Year 3 Monitoring Report
Bear Swamp Stream & Wetland Mitigation Project

Bear Swamp Stream and Wetland Mitigation Project
Year 3 Monitoring Report
DMS Project ID #100054
Robeson County, North Carolina

**RE: Response to Draft MY3 Monitoring Report Comments dated January 9, 2024
Bear Swamp Stream and Wetland Mitigation Site
Lumber River Basin – CU# 03040203 - Robeson County, North Carolina
NCDMS Project # 100054, Contract # 7516**

Bear Swamp Stream and Wetland Mitigation Project
Figure 3. Monthly Rainfall Data
Monitoring Year 3 - 2023

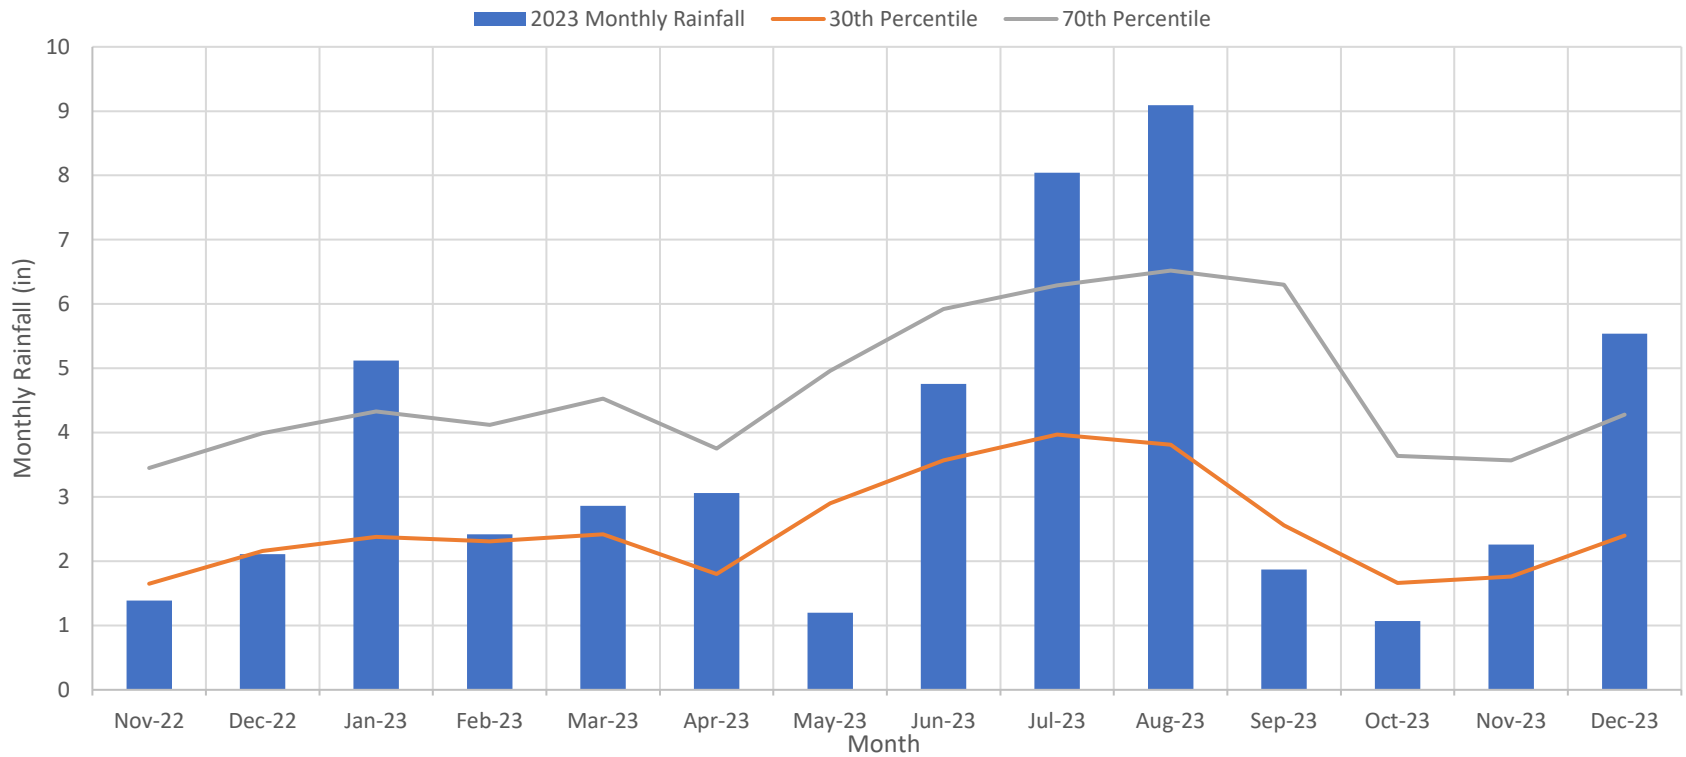
- **An additional gage will be installed near BS4 prior to the growing season in MY4. This request has been added to the report in Section 2.3.**
- ***Appendix C, Figure 3*** – *Please update rainfall data to include monthly rainfall through December 2023.*

- **Figure 3 has been updated through December 2023 using totals from the WCON7 weather station in Lumberton, as there was a data collection error with the rain**

gage, likely resulting from debris in the funnel (cleared out 1/2/2024). A discussion of the rainfall data has also been updated in report Section 2.3.

BS4 - Groundwater

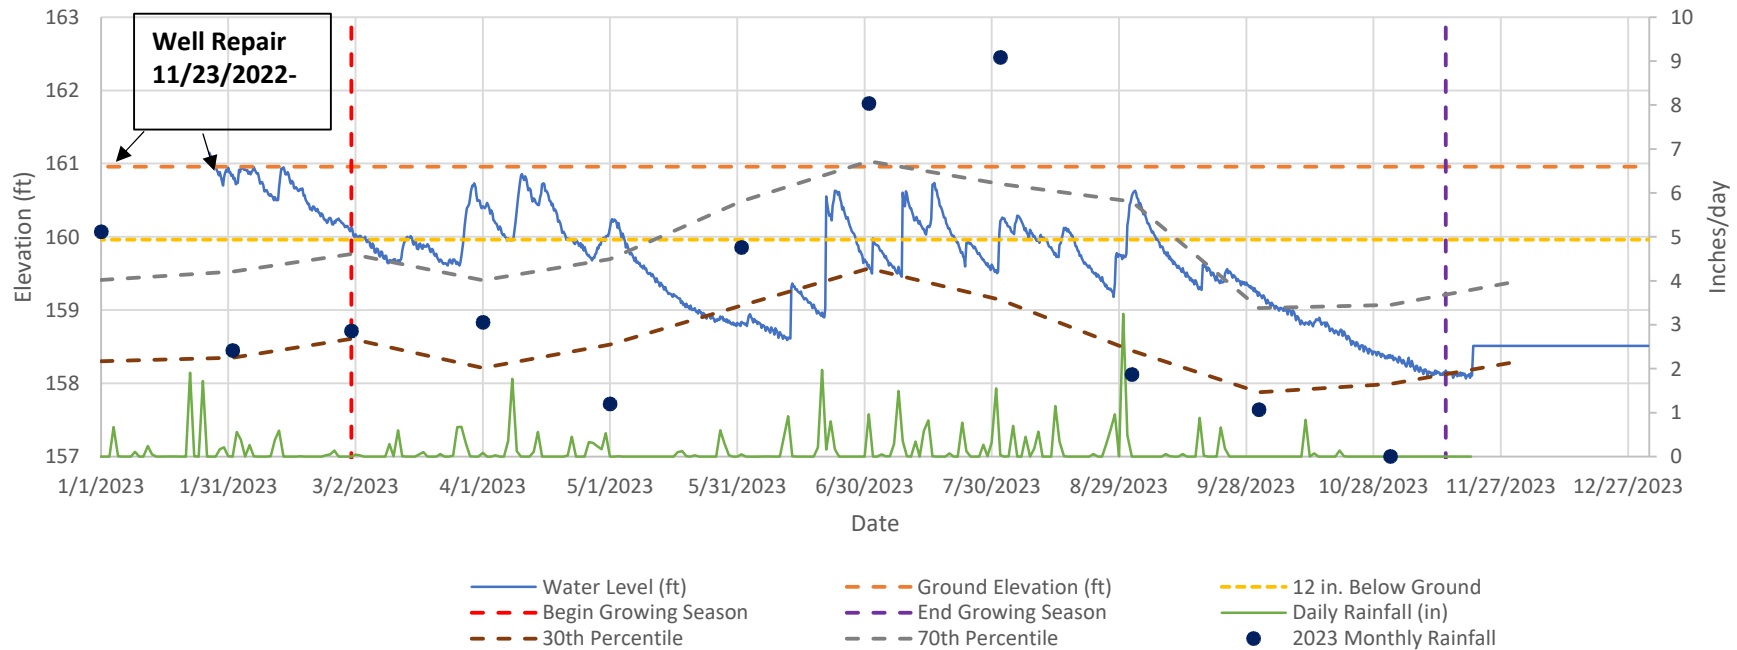
- ***IRT MY3 Site Visit*** – *During the IRT site visit an additional gauge was requested in Wetland B to provide more detail of hydrology. Given BS4 did not meet criteria for the 3rd year in a row, installing an additional gauge(s) here would be necessary to determine any potential wetland credits at risk in MY4.*
